ORIGINATION FORM

Proposed Revisions to a Standard Plans Index (Please provide all information — Incomplete forms will be returned)

Index Number: 522-002

Index Title: Detectable Warnings and Sidewalk Curbramps

LAST REVISION 11/01/19	REVISION	DESCRIPTION:	 FY 2021-22 STANDARD PLANS	DETECTABLE WARNINGS AND SIDEWALK CURB RAMPS	INDEX 522-002	SHEET 1 of 7
--------------------------------------	----------	--------------	---	--	-------------------------	------------------------

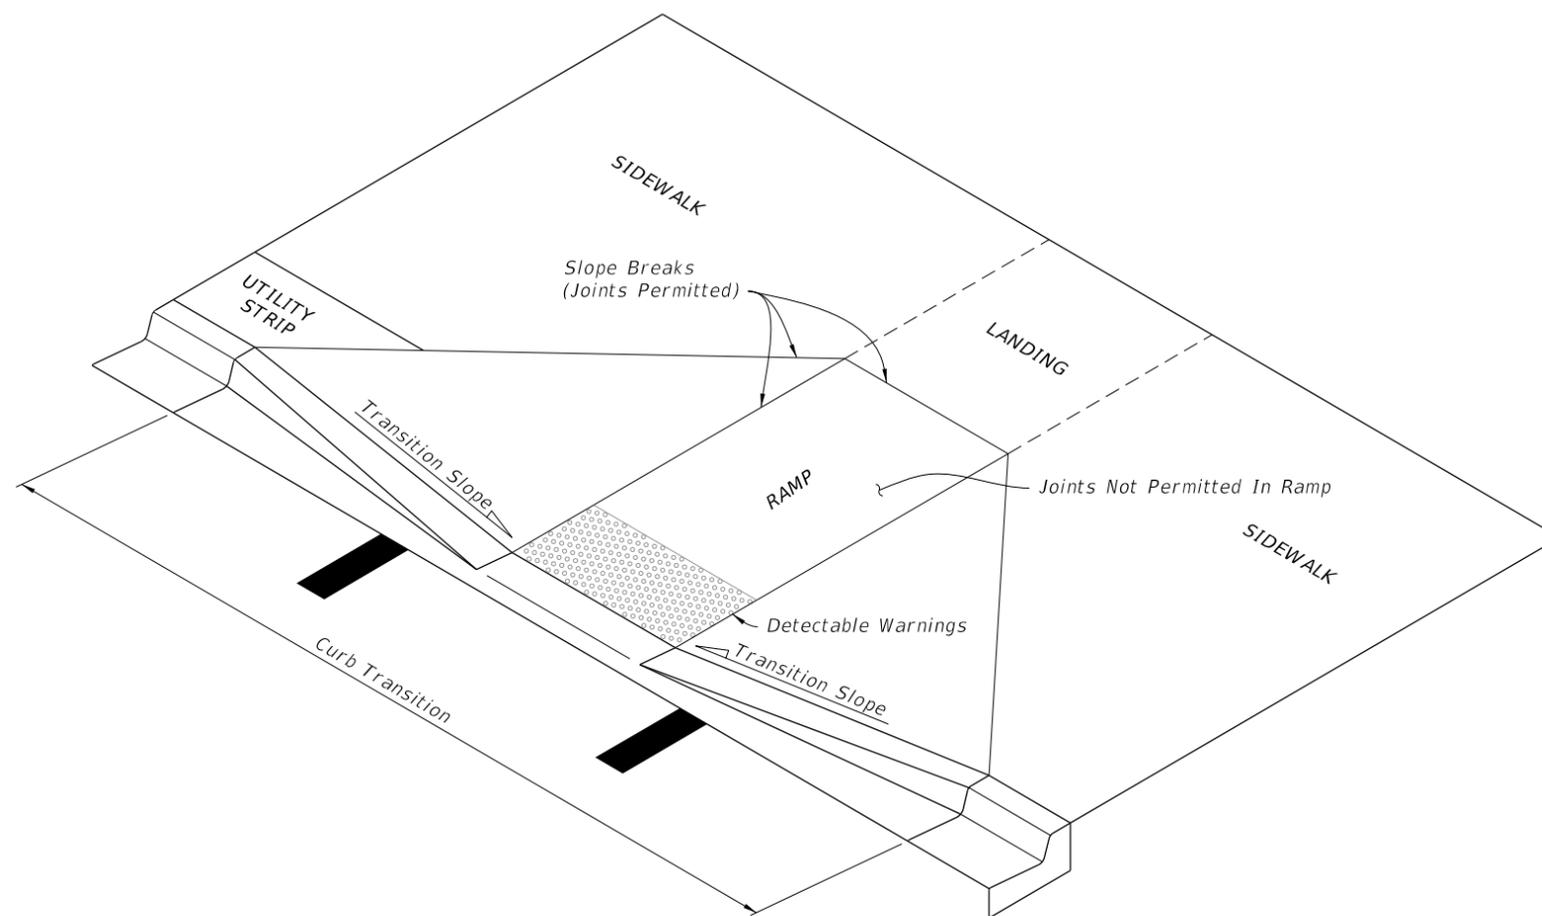
Sheet 1: Deleted General Notes #5: Detectable Warnings - Acceptance Criteria.

As long as the requirements of ADA STF 705 are a condition of being on the APL, there's no need for Note #5 in the SP. Note #5E is covered by the ADA standards and by the phrase, "securely installed even with the substrate" in our updated spec – meaning, there's no abrupt change in level at the edge of the dome mat.

5. Detectable Warnings - Acceptance Criteria:

- A. Color and texture shall be complete and uniform.
- B. 90% of individual truncated domes shall be in accordance with the Americans with Disabilities Act Standards for Transportation Facilities, Section 705.
- C. There shall be no more than 4 non-compliant domes in any one square foot.
- D. Non-compliant domes shall not be adjacent to other non-compliant domes.
- E. Surfaces shall not deviate more than 0.10" from a true plane.

SIDEWALK CURB RAMPS CR-A AND CR-B

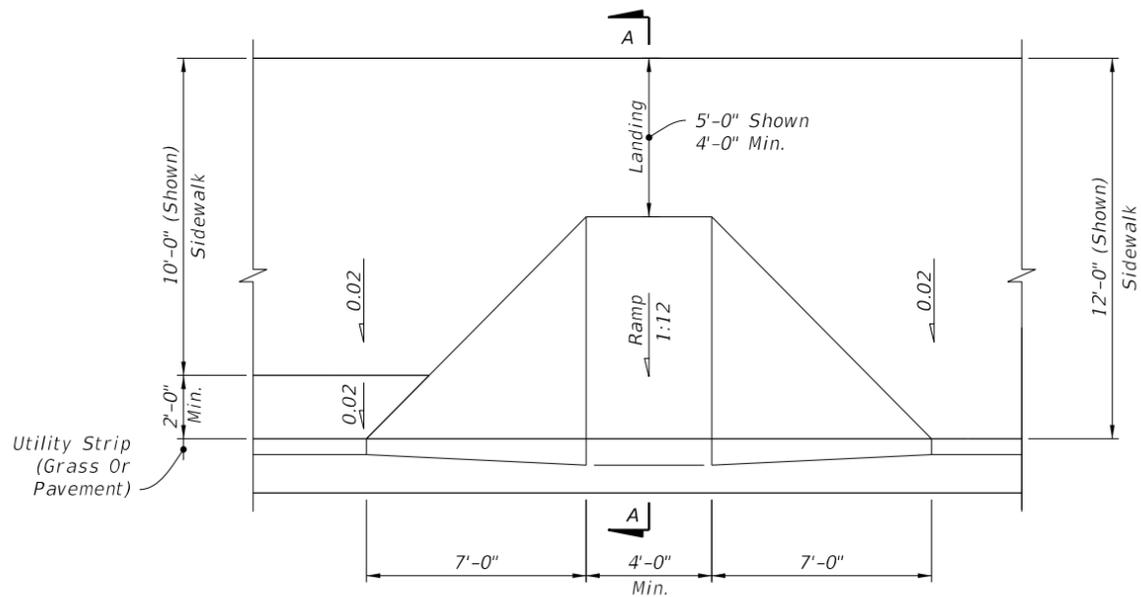
ADDED LANDING

RAILROAD CROSSING AND CURB RAMPS AT CURBED RETURNS

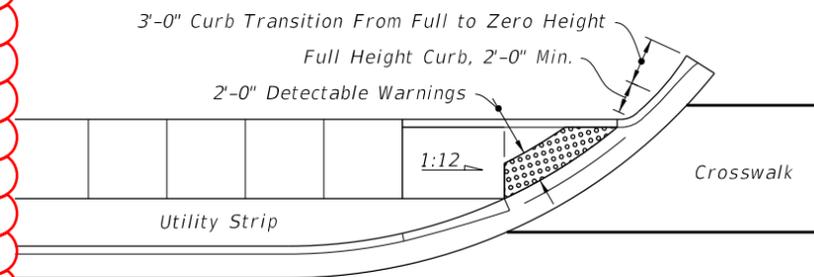
ADDED NEW DETAIL
"CURB RAMP OUTSIDE RADIAL RETURN"
